SSD_7417: REGIMENT MIXED-USE REDEVELOPMENT, UNIVERSITY OF SYDNEY, DARLINGTON CAMPUS

UNIVERSITY OF SYDNEY RESPONSE TO SUBMISSIONS

18 MAY 2017

An extract of drawing DA025 Section 1 below illustrates the vertical fins shaded dark grey and casting shadows in elevation:

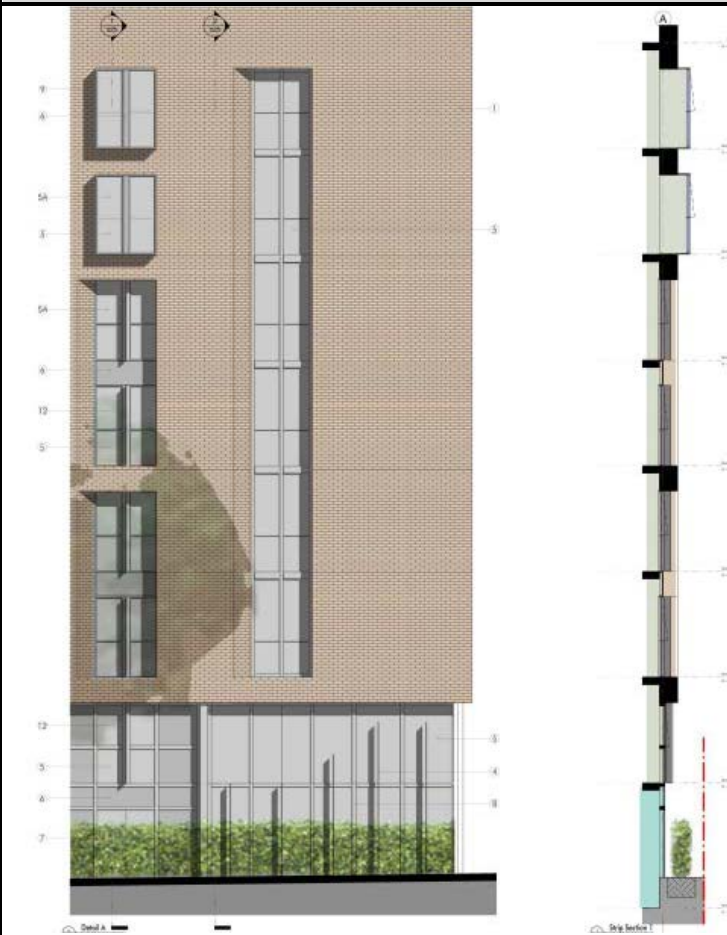
f) solar screens should be provided to windows to reduce heat load, particularly for rooms that are north and west facing;	<p>Disagree: Solar screens will not be provided to windows as the existing treatment of the windows has been designed to manage heat loads especially to north and west facing dorm rooms.</p> <p>The design incorporates 400mm deep set paired apartment windows that provide integrated self-shading to the glazing, the sides and top overhang of the typical room window. Shading is also provided by the overhang at level 3 shading level 2 rooms. See below extracts from the architectural design report and drawings that demonstrates the self-shading design of the windows (refer to page 57 page the Architectural Design Report. Image of intent – extract provided below).</p> <div data-bbox="1567 793 2677 1249" data-label="Image">  </div> <p>(Refer to DA 025 that shows circa 400mm overhang to level 2 room windows).</p> <p>Furthermore, between the pair of windows a 200mm projecting metal fin will be incorporated to provide additional sun-shading and articulation to the façade (refer to page 38 of the Architectural Design Report which shows the 200mm projecting fin at the end of the party wall - image extract provided below):</p>

The proposed development is modelled to show that it meets the requirements of the Section J energy efficiency provisions of the NCC using the JV3 methodology (refer **Attachment 1.03**) - through the use of reveals and overhangs in the brick façade, and the selection of appropriate glazing with a low U value and Solar Heat Gain Coefficient. Based on this modelling the introduction of solar screens is not required. The attached BCA Section J assessment (refer **Attachment 1.03**) from JHA Consultants outlines the modelling information and glazing performances that will be required.

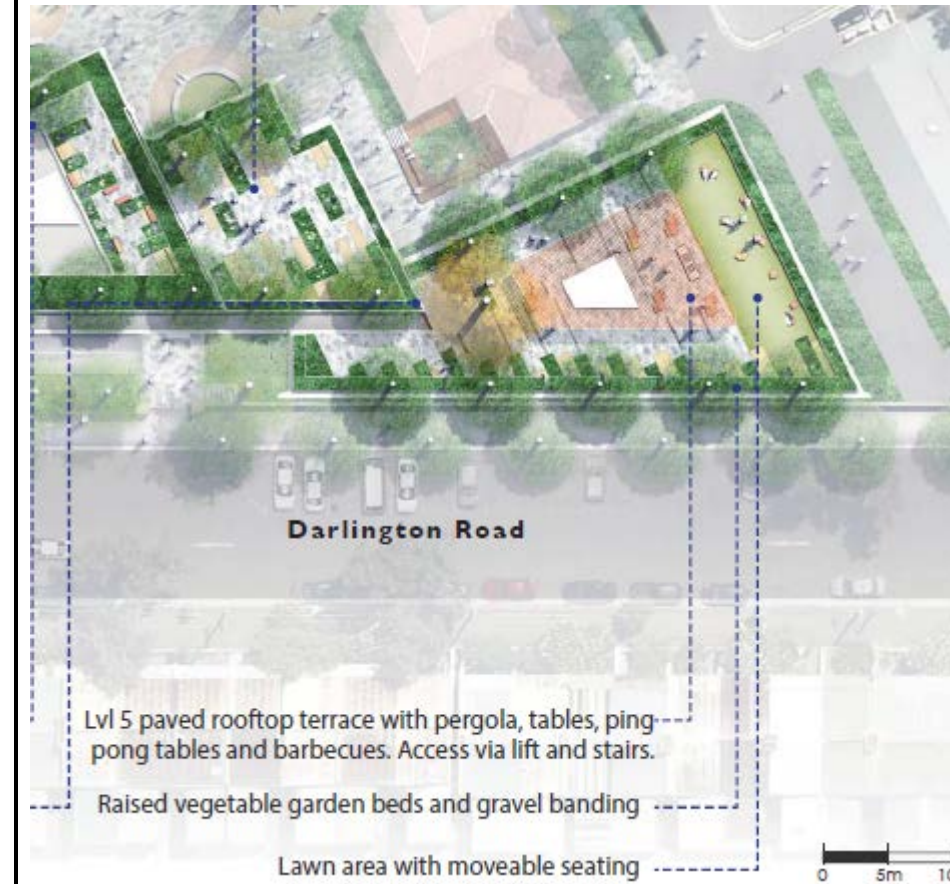
- g) the rooftop terraces should include weather protected areas such as solar shade and protected wind breaks; and

Protection for the sun is provided by a rooftop 2.7m high steel framed/hard wood pergola structure. The pergola will provide solar protection in summer and quality of openness and light at other times of the year so students can enjoy the main outdoor terrace environment.

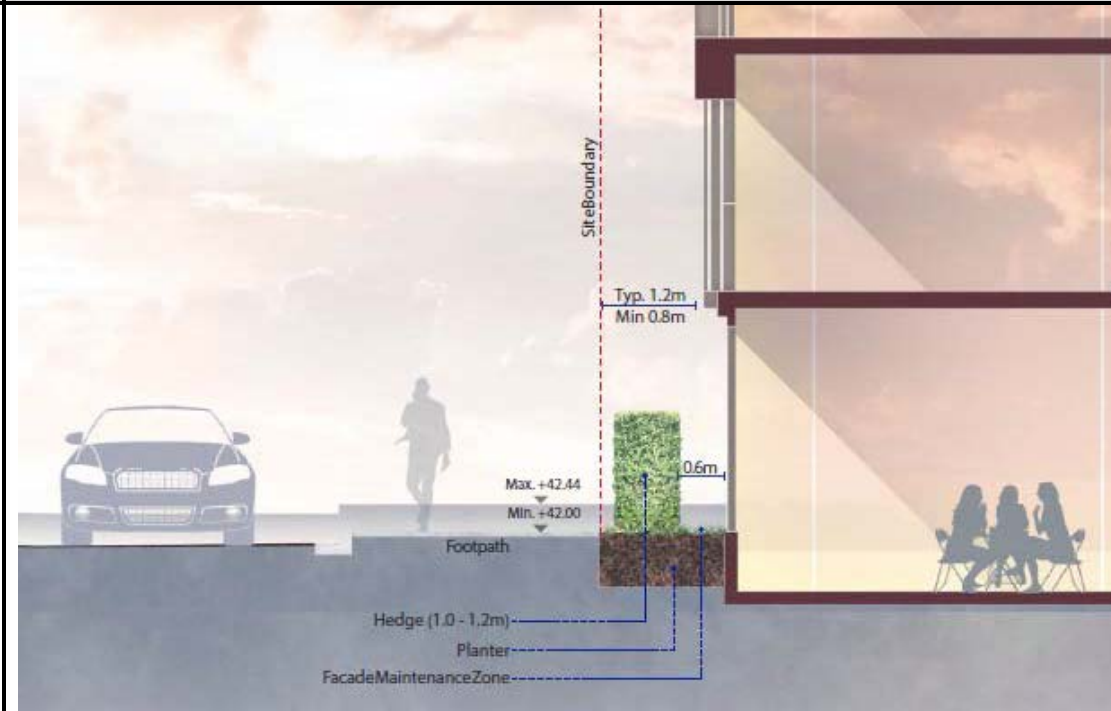
5. The scale and generic commercial quality of the proposed curtain wall glazing along the lower floors of City Road and at the City Road and Darlington Road intersection is not supported.	<p>City Road Lower Floor Glazing:</p> <p>The City Road Lower floor glazing system is proposed to be a slim line framing system that is modulated and broken up by exposed concrete columns, coloured back glass, vision glass and vertical shading fins (at level 2). The combination of these elements will provide a varied visual treatment along City Road. Furthermore the glazing is fronted by extensive buffer hedge landscaping to soften the edge treatment and provide a degree of screening and privacy both to the public and occupants.</p>  <p>This street elevation shows the glazing modulation along City Road.</p>

This part elevation shows the interplay of concrete columns, slimline framing, vertical shading fins and landscaping that will provide variation along the street.

Concrete columns and glass are suitable durable materials against vandalism.

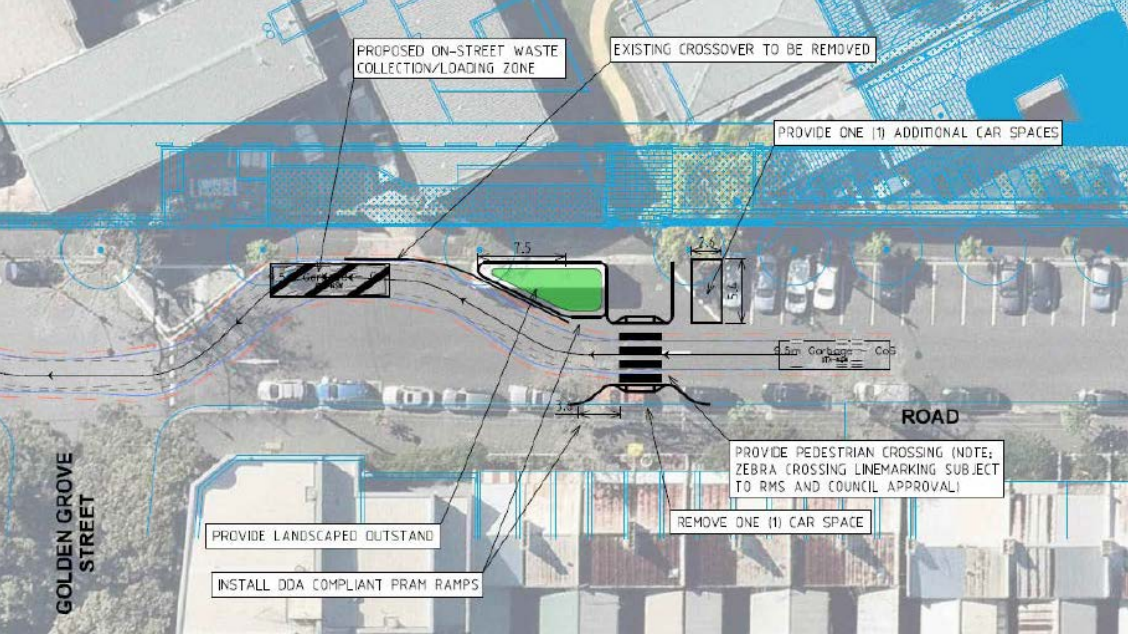
7. Very little information has been provided on the environmental performance of the building. Details are required on extents of mechanical and cross ventilation and the extent of solar access and sun shading to bedrooms and shared spaces.	<p>Refer to the UoS Response to DPE issue 1f) and attached Regiment Section J Assessment Letter by JHA Consultants.</p> <p>The development shall incorporate passive design principals focused around strategic glazing, a refined shading strategy, orientation and application of thermal mass to minimise the reliance on mechanical air conditioning and deliver a high quality indoor environment.</p> <p>The accommodation areas will not have air conditioning. However, they will benefit from a well-designed natural ventilation strategy that has been developed through extensive calculations and modelling.</p> <p>Mixed mode ventilation requirements will be met within all common areas of the building using the cross flow ventilation strategies shown below. All dorm rooms will have a ceiling fan and operable window to promote sustainable strategies for ventilation and cooling.</p>

SUPPLEMENTARY DPE & GAO ISSUES	USYD PROJECT RESPONSE
	<p>TYPICAL CROSS FLOW VENTILATION BREEZEWAYS</p> 
<p>8. Whilst small vertical blades are indicated on some windows, the environmental performance of the building is not clear. A review of the proposed solar shading is required to ensure dorm rooms and common areas are appropriately protected from direct West, East and Northern sunlight. Design of sun shading should be integrated with the overall facade design.</p>	<p>Refer to the UoS Response to DPE issue 1f) and attached Regiment Section J Assessment Letter by JHA Consultants.</p>
<p>9. The argument for smaller than minimum room sizes is based on maintaining reduced rental levels and the provision of greater than boarding house quantities of shared space and amenities. Whilst the comparison to boarding houses is accepted, little data has been provided on the comparison with other student accommodation in regards to cost and provision of shared amenities, beyond those already operated by the University and located within existing, upgraded buildings. In order to support the reduced room size the GA requires data that compares proposed room rental rates with other student housing providers and a comparison of room sizes with the provision and location of shared spaces. Additionally it is noted that an increase of bedroom sizes to the NSW minimum could be offset if necessary by greater diversity of room types to include shared room and multi-room arrangements, now common in student accommodation.</p>	<p>Refer to the UoS Response to DPE issue 1d) and 1e)</p>
